Access Compliance Report

Public Rights-of-Way

Intersection ID: N/A	Main Street: VIZCAYA_CT	Cross Street: BISCAY_DR	Location: SE
ADA ID: 41B9226DBE7F	Ramp Type: Perp	Initial Pass/Fail: Fail	Overall Compliance: No
Severity Score: 8.75			
Codes/Mitigation Info/Possible Solution		Field Measurements/Component Compliance

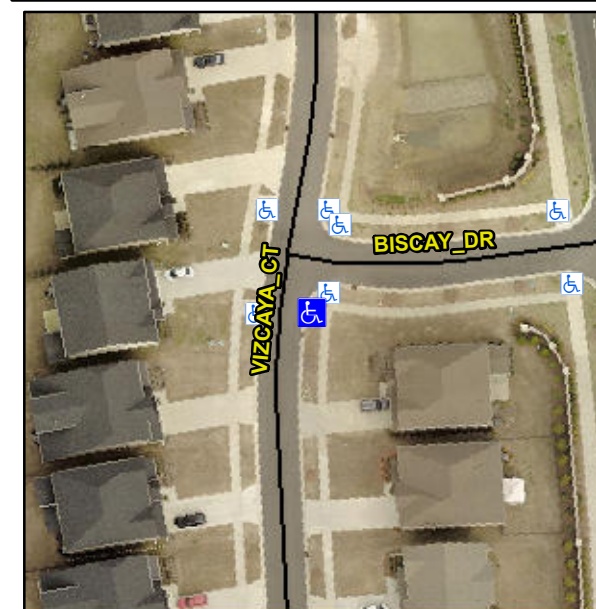
Remove & Replace Entire Ramp.

R304.5.1

Compliance	Description	Data	Compliance	Description	Data
N/A	Ramp Length (in)	93.0	Yes	Ramp Slope (%)	5.4
No	Ramp Width (in)	45.0	Yes	Ramp XSlope (%)	1.4
N/A	Flare Type LT	N/A	N/A	Flare Type RT	N/A
N/A	Flare Slope LT (%)	N/A	N/A	Flare Slope RT (%)	N/A
N/A	Flare Traversable LT?	N/A	N/A	Flare Traversable RT?	N/A
N/A	Landing Length (in)	N/A	N/A	DWS Provided?	N/A
N/A	Landing Width (in)	N/A	N/A	DWS Contrast?	N/A
N/A	Landing Slope (%)	N/A	N/A	DWS Length (in)	N/A
N/A	Landing X Slope (%)	N/A	N/A	DWS Full Width?	N/A
N/A	Landing Curb? (Y/N)	N/A	N/A	DWS Offset (in)	N/A
N/A	Shared Landing?	N/A			
N/A	Gutter Ponding?	N/A	N/A	Gutter Slope (%)	N/A
N/A	Gutter Lip Ht (in)	N/A	N/A	Gutter X Slope (%)	N/A
N/A	Painted X Walk1?	No	N/A	Painted X Walk2?	N/A
	X Walk 1 Direction	To W		X Walk 2 Direction	N/A
N/A	X Walk 1 Width (in)	N/A	N/A	X Walk 2 Width (in)	N/A
	X Walk 1 Slope (%)	3.9		X Walk 2 Slope (%)	N/A
	X Walk 1 X Slope (%)	0.8		X Walk 2 X Slope (%)	N/A
